# City of Richmond

## Report to Development Permit Panel

**File:** DP 15-694616

**Re:** Application by Dava Developments Ltd. for a Development Permit at a Portion of  
10199 River Drive

**BUILDING 15 (&16) - EAST ELEVATION**

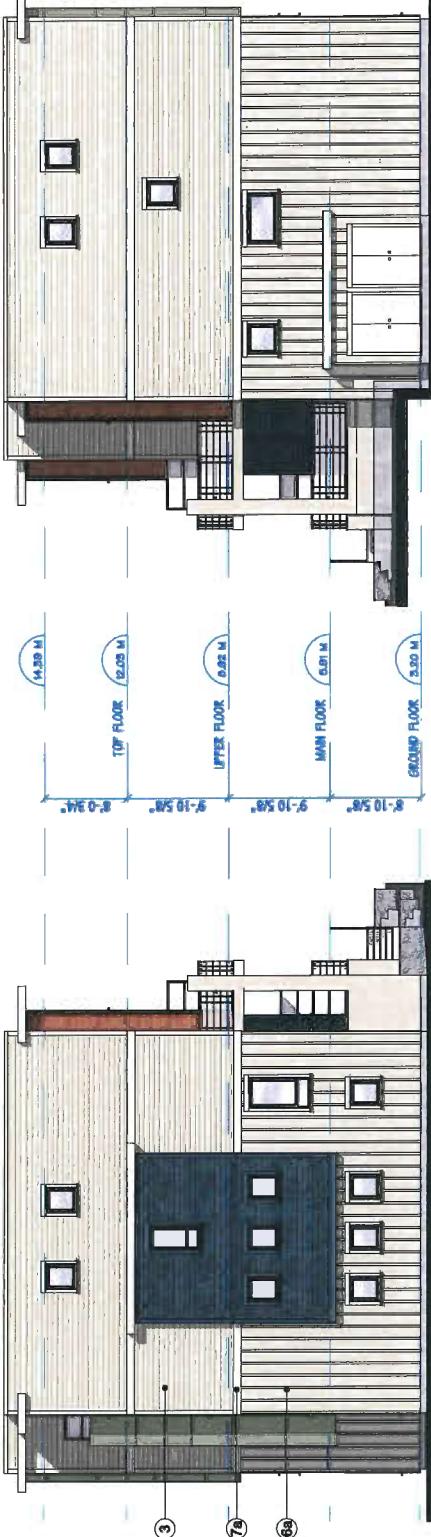
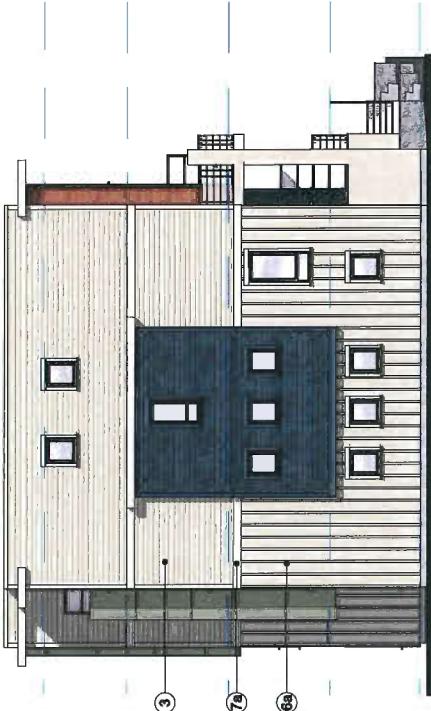
- Applicant needs to provide clarity to the rationale for using vertical as opposed to horizontal banding in some townhouse buildings, e.g. in Buildings 15 and 16 – ***The form and character of buildings 15 and 16 are contemporary to match with and provide transition from the modern form of Building G of Phase 1.***

## 3 36" HT. WOOD FENCE

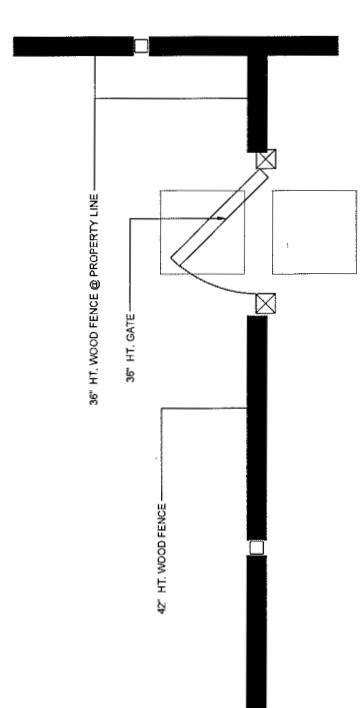
- Appreciate the interior planting in the proposed development – **Noted**.
- Consider lowering the proposed 42-inch rail fence adjacent to the park to provide better visual connection – **Incorporated. Fence height reduced to 36-inch height.**
